Re: Permit Modification – Attachment 5 and Attachment 14
McCommas Bluff Landfill, TCEQ Permit No. 62
Dallas County, Texas

PERMIT MODIFICATION

**ATTACHMENT 5
GROUNDWATER CHARACTERIZATION REPORT AND
GROUNDWATER MONITORING PLAN**

LANDFILL GAS MANAGEMENT PLAN

FIGURE
5B.1

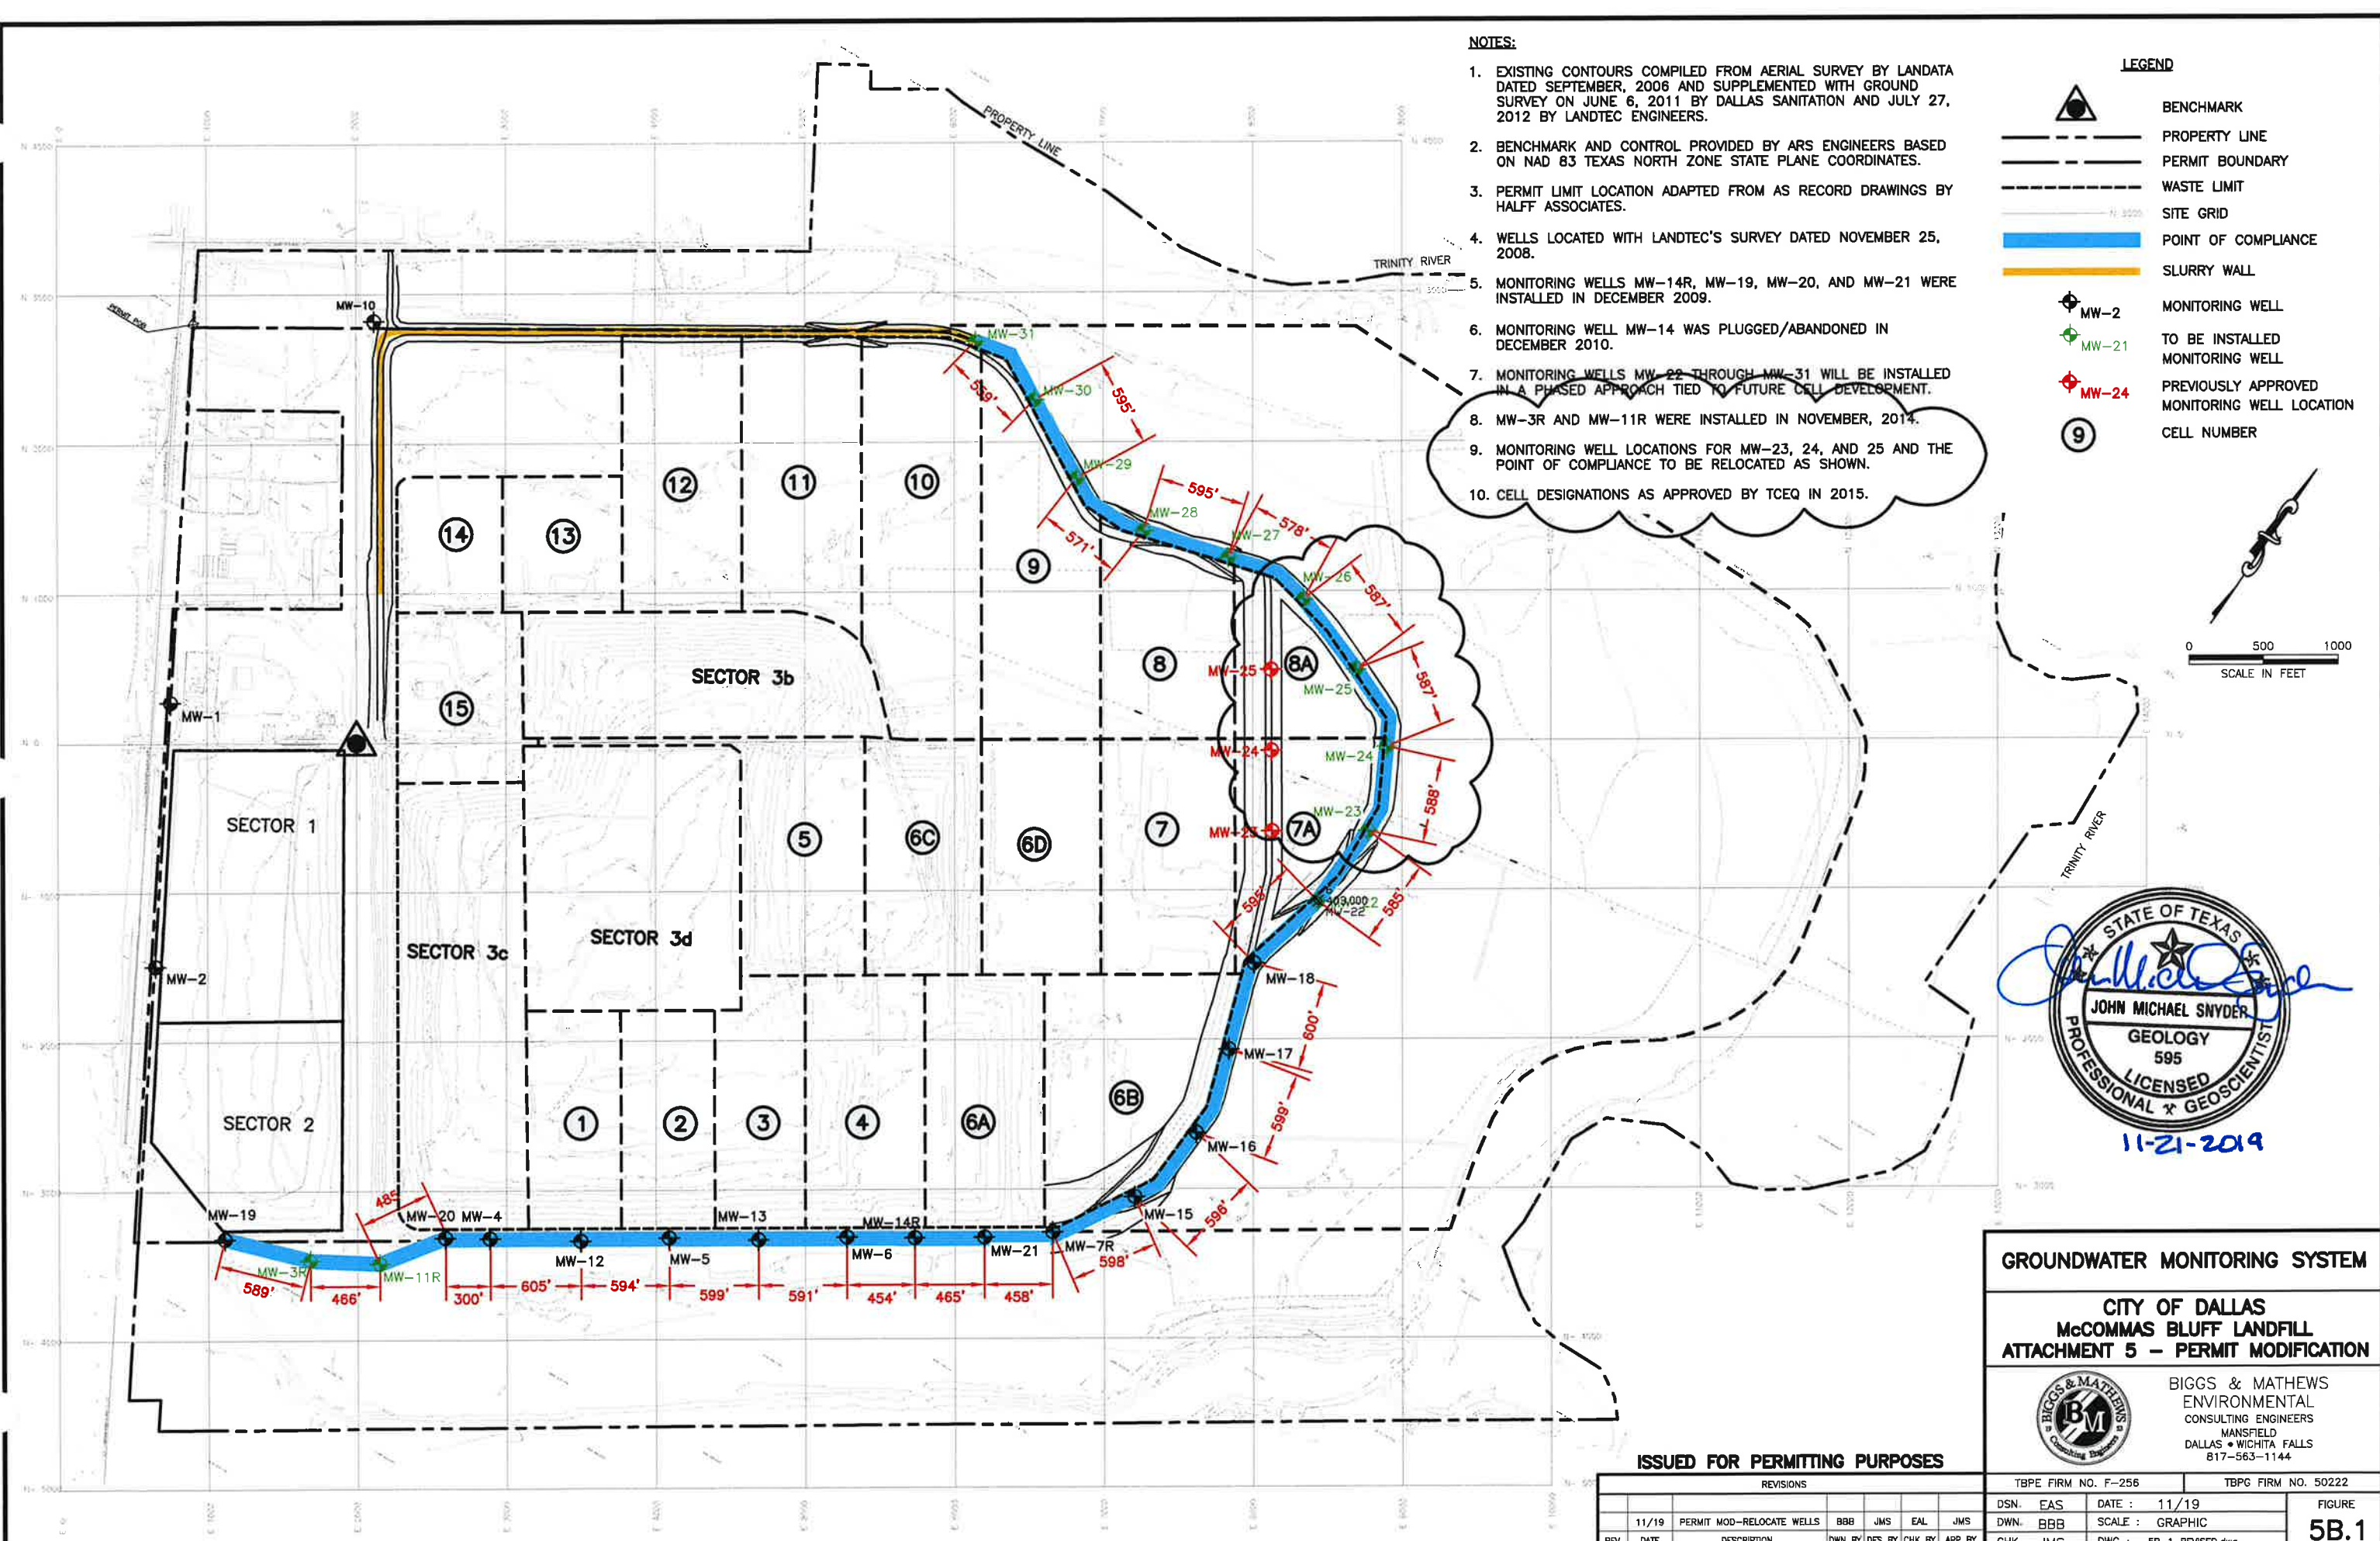
The system will ultimately consist of 29 monitoring wells. MW-1, MW-2, and MW-10 are existing upgradient wells. MW-3R, MW-4, MW-5, MW-6, MW-7R, MW-11R, MW-12, MW-13, MW-14R, MW-15, MW-16, MW-17, MW-18, MW-19, MW-20, and MW-21 are currently installed. ~~MW-3R and MW-11R (which will replace existing MW-3 and MW-11) will be installed following approval of this modification.~~

The other proposed wells will be installed in a phased approach tied to future cell development. Specifically, MW-22 through MW-25 will be installed prior to waste filling in Cell 7A, MW-26 through MW-28 will be installed prior to waste filling in Cell 8, and MW-29 through MW-31 will be installed prior to waste filling in Cell 9. The monitoring well locations are shown on Figure 5B.1. The monitoring well details are included on Figure 5B.2.

| REVISIONS | | | | | | | TBPE FIRM NO. F-256 | | | TBPG FIRM NO. 50222 | | |
|-----------|-------|---------------------------|--------|--------|--------|--------|---------------------|-----|---------|---------------------|--------|--|
| | 11/19 | PERMIT MOD-RELOCATE WELLS | BBB | JMS | EAL | JMS | DWN. | BBB | SCALE : | GRAPHIC | 5B.1 | |

EXISTING GCCS

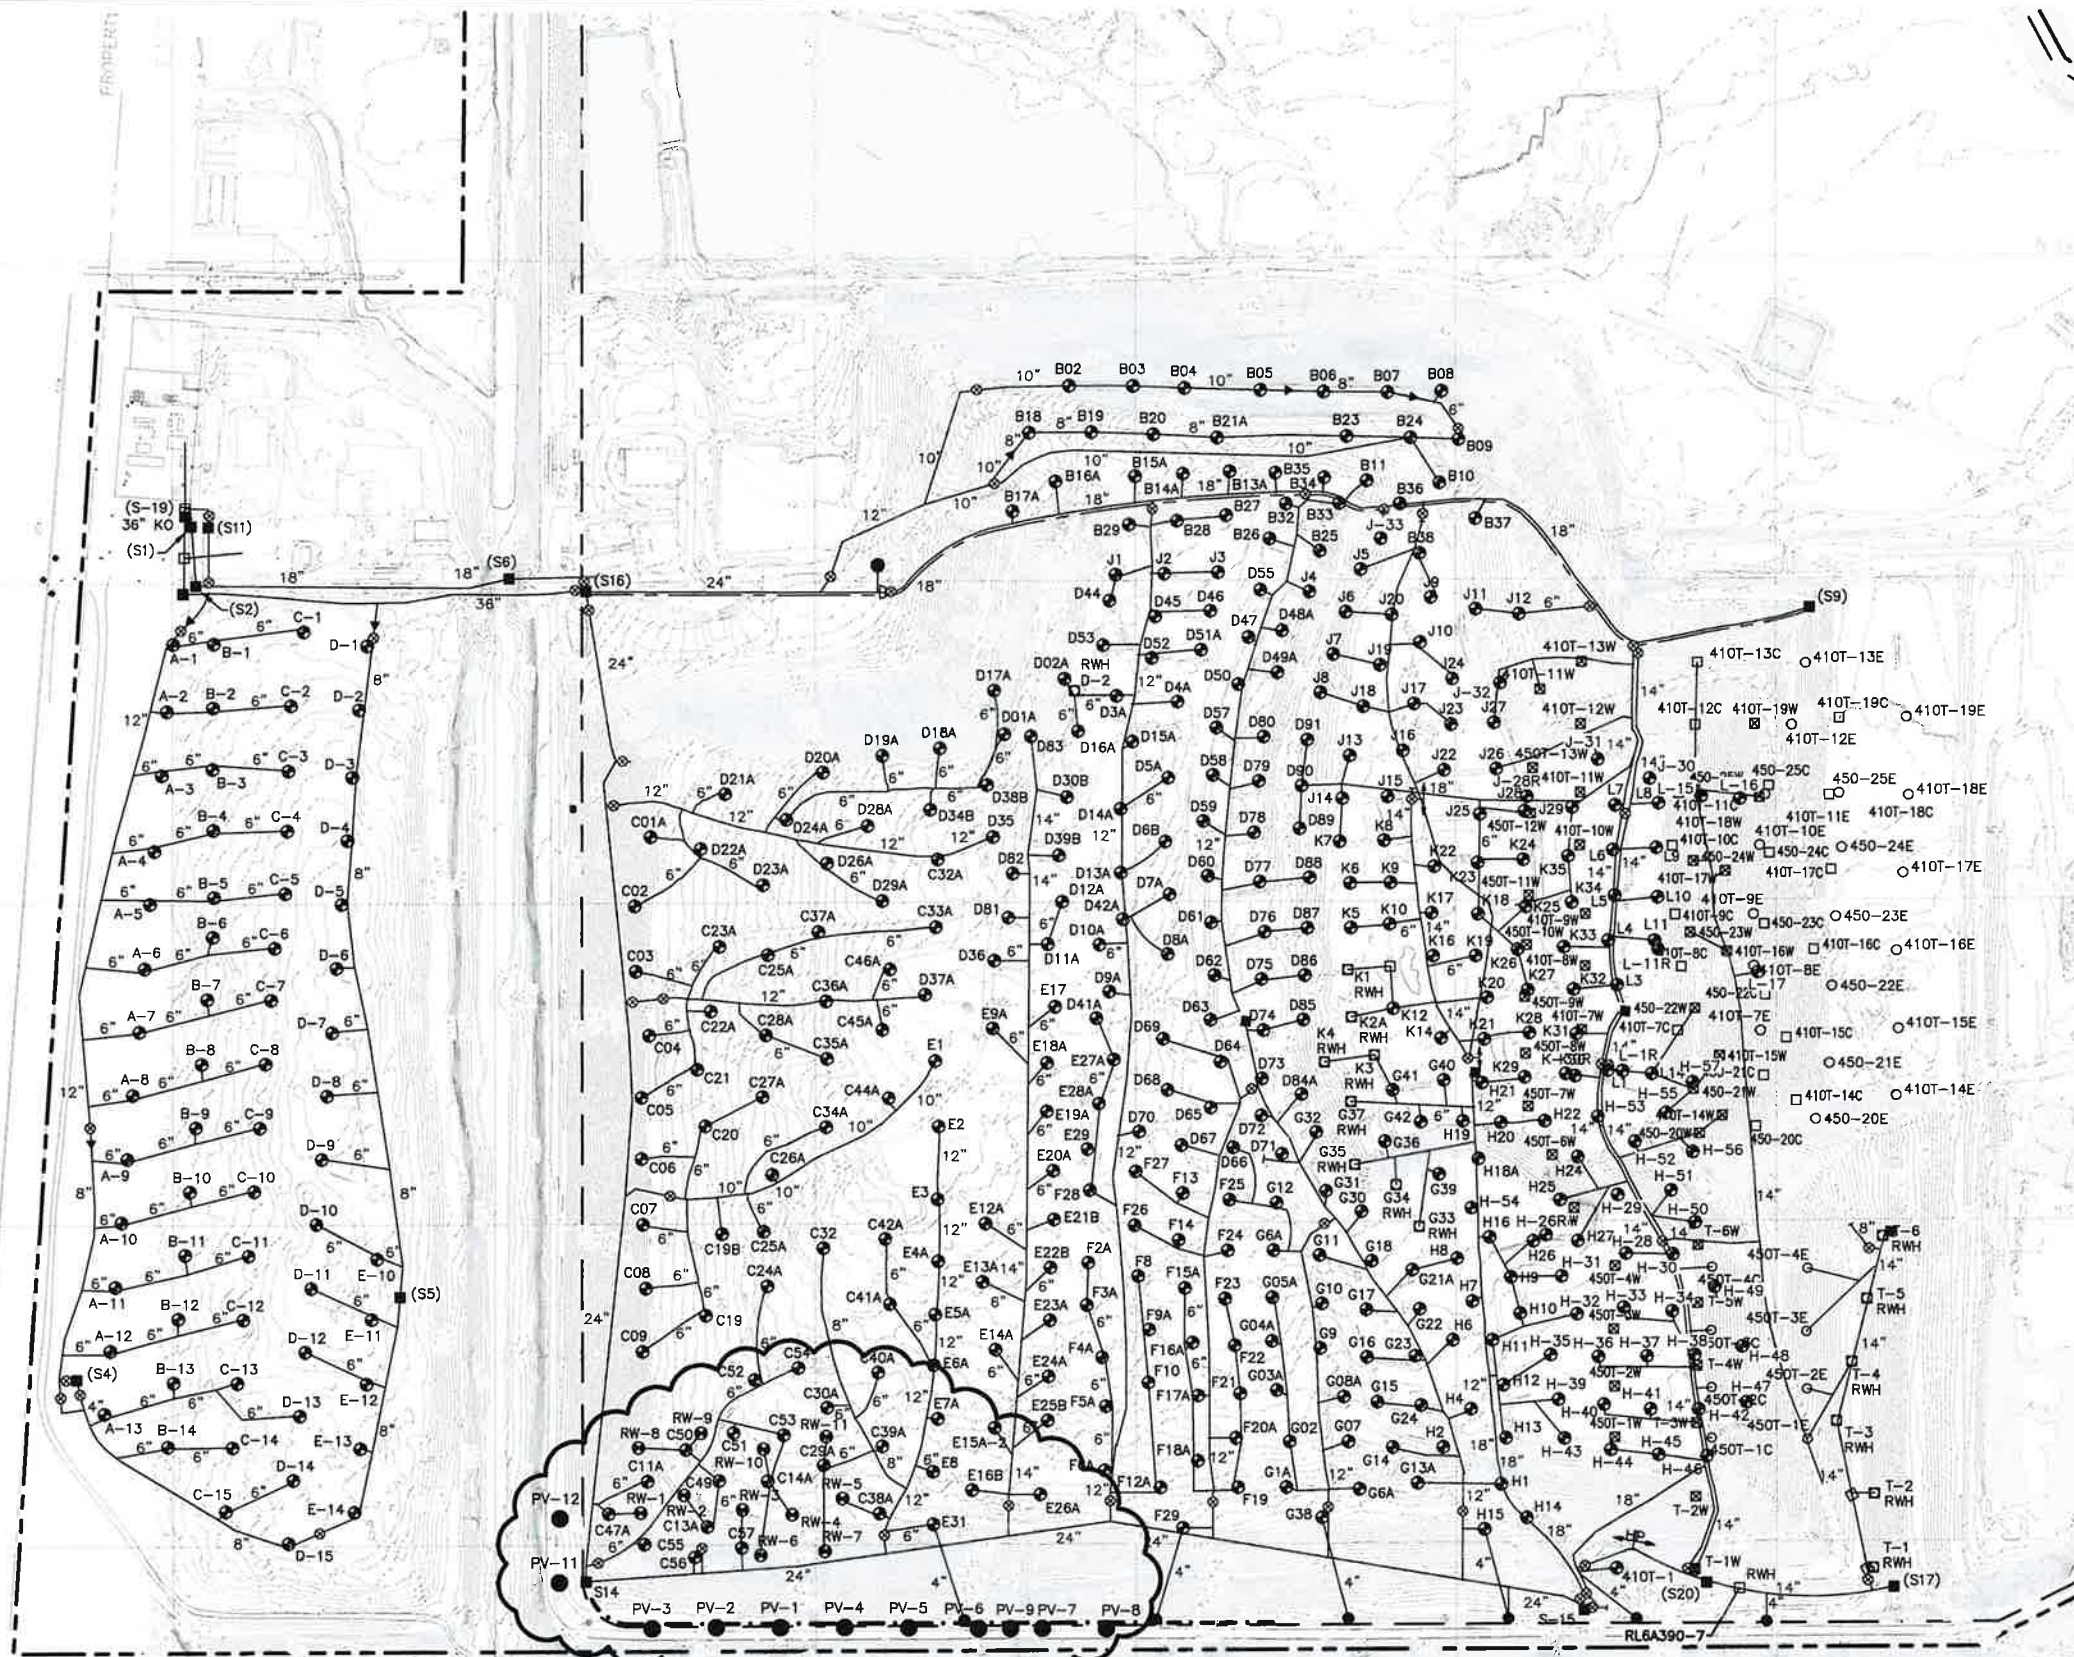
Currently, the site has an active LFG collection and control system (GCCS), as shown in Appendix D of Appendix 1 on Drawing 1. The existing GCCS consists of vertical LFG extraction wells, a piping network, a condensate management system, and a blower/flare facility, and a landfill gas-to-energy (LFGTE) facility. The existing blowers provide vacuum to the extraction wells through the LFG collection piping network. The extracted LFG is routed from the collection points to the LFGTE facility. Any remaining extracted LFG not sent to the LFGTE facility is diverted to an on-site flare where the gas is combusted.

In addition, a shallow clay cutoff trench has been constructed on the south side of the site adjacent to Sector 3C, Cell 1, and Cell 2. This trench was installed near the limits of waste, above the anchor trench, to serve as a barrier to prevent potential migration of LFG using the liner protective cover layer as a pathway. To install the trench, all of the soil above the anchor trench, including the protective cover, was excavated. This area was then backfilled with compacted clay to ground surface.

| REVISIONS | | | | | | | | | | TBPE FIRM NO. F-256 | | TBPG FIRM NO. 50222 | |
|-----------|-------|------------------|--|--|--------|--------|--------|--------|------|---------------------|---------|-------------------------|--------------|
| | 11/19 | ADDED COMPONENTS | | | SRC | ALM | JHP | JHP | DWN. | SRC | SCALE : | | GRAPHIC |
